UNITED STATES PATENT AND TRADEMARK OFFICE

APPLICATION NO.	FILING DATE	FIRST NAMED INVENTOR	ATTORNEY DOCKET NO.	CONFIRMATION NO.
09/974,780	10/09/2001	Max Schaldach	7040-46	6883

Office Action Summary	Application No. 09/974,780	Applicant(s) SCHALDACH ET AL.	
	Examiner Jessica R Baxter	Art Unit 3731

2. Claims 1-60 are rejected under 35 U.S.C. 102(b) as being anticipated by U.S. Patent No. 5,931,867 to Haindl.

FIG.1

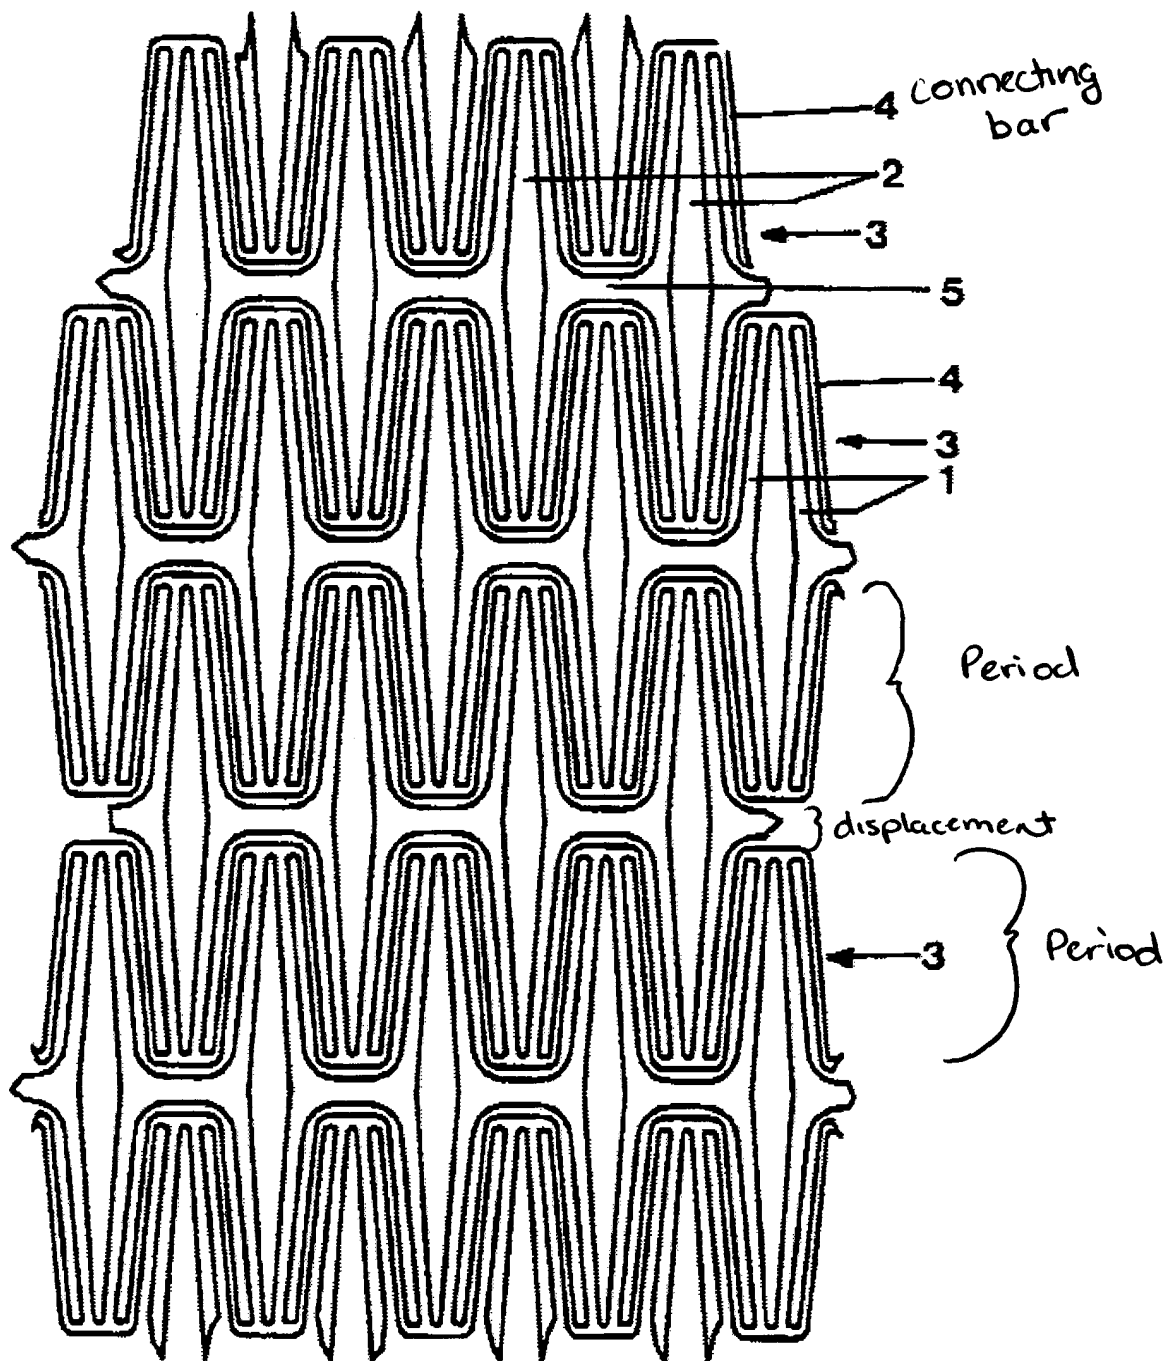
Regarding claims 1 and 59, Haindl discloses a stent, for expansion from a first condition into an expanded second condition in which it holds a vessel in an expanded state (Column 1 lines 58-60), said stent comprising: a tubular body, a peripheral surface of which is formed by a plurality of support portions that extend in a longitudinal direction of the stent, the support portions comprising: a plurality of bar elements; and a plurality of connecting bars, extending rectilinearly in the longitudinal direction of the stent when in the first condition, that connect the bar elements; wherein the support portions form a plurality of support portion groups with at least a first support portion and a second support portion in adjacent relationship thereto in a peripheral direction of the stent, the bar elements of which extend in a meander configuration in the longitudinal direction of the stent, and wherein a first engagement point of the connecting bars engages the first support portion and a second engagement point of the connecting bars engages the second support portion, such that the first and second engagement points are spaced apart from each other in the longitudinal direction of the stent and the connecting bars are configured and arranged so the spacing in the longitudinal direction between the first and second engagement points decreases upon expansion of the stent (see attached FIGS 1 and 2 for details).

Regarding claims 34, 35, 36, 37, 38, 39 and 40, Haindl discloses that the bar elements of the first and second support portions are of substantially the same periodic configuration and a length of the connecting bars is such that the adjacent bar elements in the first condition of the stent are displaced relative to each other by up to a quarter period in the longitudinal direction of the stent (see FIG. 1).

FIG. 2

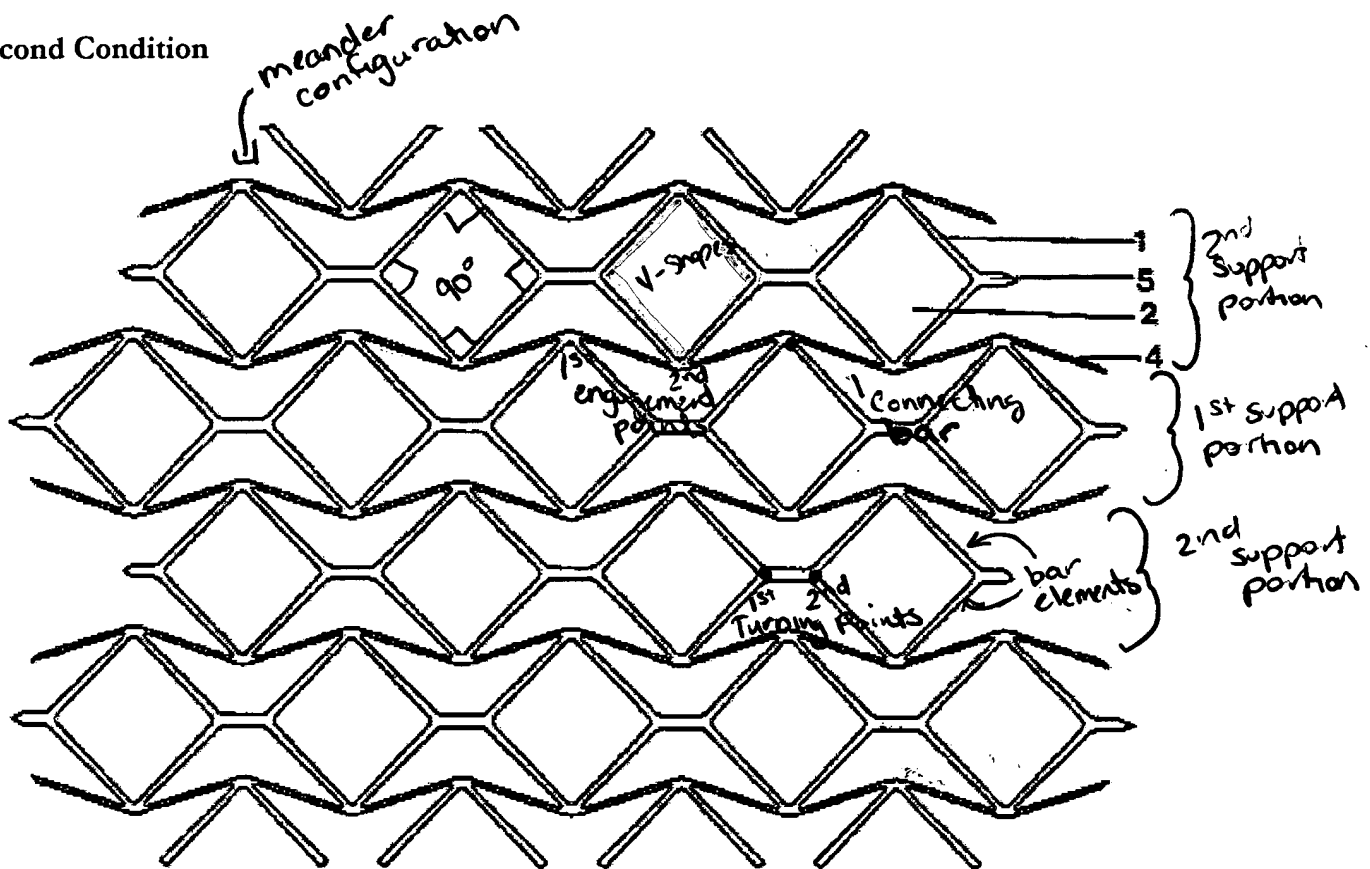
points decreases upon expansion of the stent in the same manner. Compare attached FIGS. 1 and 2 connecting bars.

Regarding claims 3 and 5 Haindl discloses that at least the first engagement points of the connecting bars are located near a turning point of the bar element to which the connecting point is engaged (See FIG. 2).

Regarding claims 4 and 6, Haindl discloses that the second engagement points of the connecting bars are located near a turning point of the bar element to which the connecting point is engaged (see FIG. 2).

Regarding claims 7, 8, 9 and 10, Haindl discloses that the connecting bars are of a substantially straight configuration (See FIG. 2).

Regarding claims 11, 12, 13, 14 and 15, Haindl discloses that a connecting line between the first and second engagement points extends *substantially* in the longitudinal direction of the stent (see FIG. 2).

Regarding claims 16, 17, 18, 19, 20 and 21, Haindl discloses that at least one support portion is formed by bar elements extending in a meander configuration in the longitudinal direction of the stent, wherein the bar elements comprise two bar element portions that are adjacent in the longitudinal direction of the stent and which extend between a turning point to form the limbs of a V-shape (see FIG. 2).

Regarding claims 22, 24, 26, 28, 30 and 32, Haindl discloses that the bar element portions include an angle of between 80° and 100 °(see FIG.2).

Regarding claims 23, 25, 27, 29, 31 and 3, Haindl discloses that the bar element portions include an angle of 90°(see FIG. 2).

Regarding claims 41, 42, 43, 44, 45, 46, 47, 48 and 49, Haindl discloses that the bar elements of the first and second support portions are of substantially the same period configuration and a length of the connecting bars is such that in the second condition of the stent the adjacent bar elements extend substantially in phase with each other with respect to the longitudinal direction of the stent (see FIG. 2).

Regarding claim 58, Haindl discloses that at least one support portion formed by a bar element, the direction of curvature of which changes in a central region between a pair of turning points (see FIG. 2).
